26-612

4 August 2026

Westhaven Residential Limited Partnership

188 Beaumont Street Traffic Response to Comments from Invited Parties

Figure 1 – Double Sided Bike Rings for 12 Visitor Cycles on Ground Level (as shown in red outline)

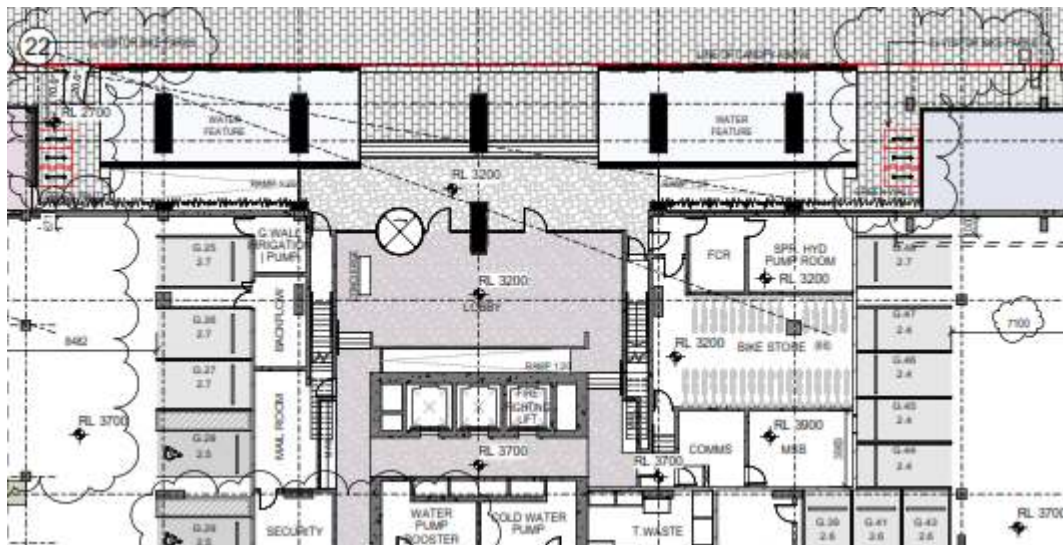
Auckland Council's traffic engineer has outlined the Project has a shortfall in visitor bicycle parking.³ Twelve visitor bike spaces are required under the Auckland Unitary Plan (AUP), and three double sided bike racks will be located either side of the lobby at the street level providing 12 visitor bicycle parks. The Ground Floor plan has been annotated to show where they will be placed shown below and included in **Appendix A** which replaces the existing ground level floor plan in the Architectural Drawings pack. The Project now complies with the AUP standard E27.6.2.5(T81).

Figure 4 – Median Island Cut Back as requested by Council Reviewer

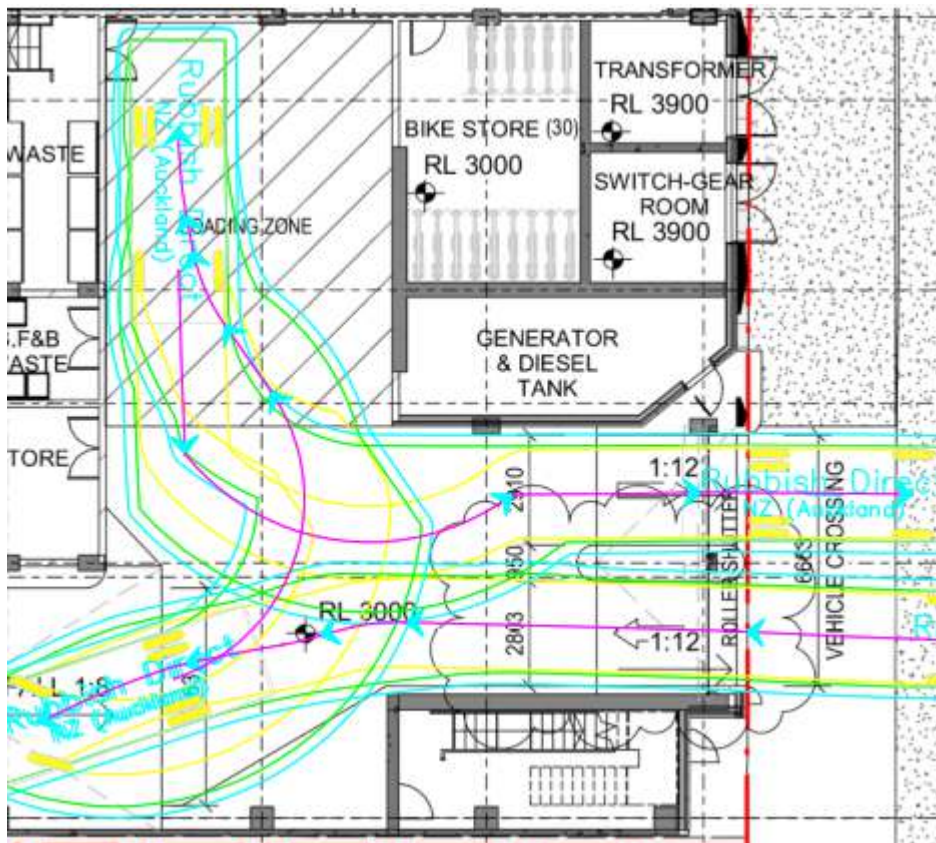
Auckland Transport outlines the ITA indicates that the truck slightly tracks over the proposed median separation at the access.¹² The median island has now been shortened by 750mm to ensure there is clearance for the rubbish truck and it no longer tracks over the proposed median separation at the access. The original plot superimposed on the new island is shown below.
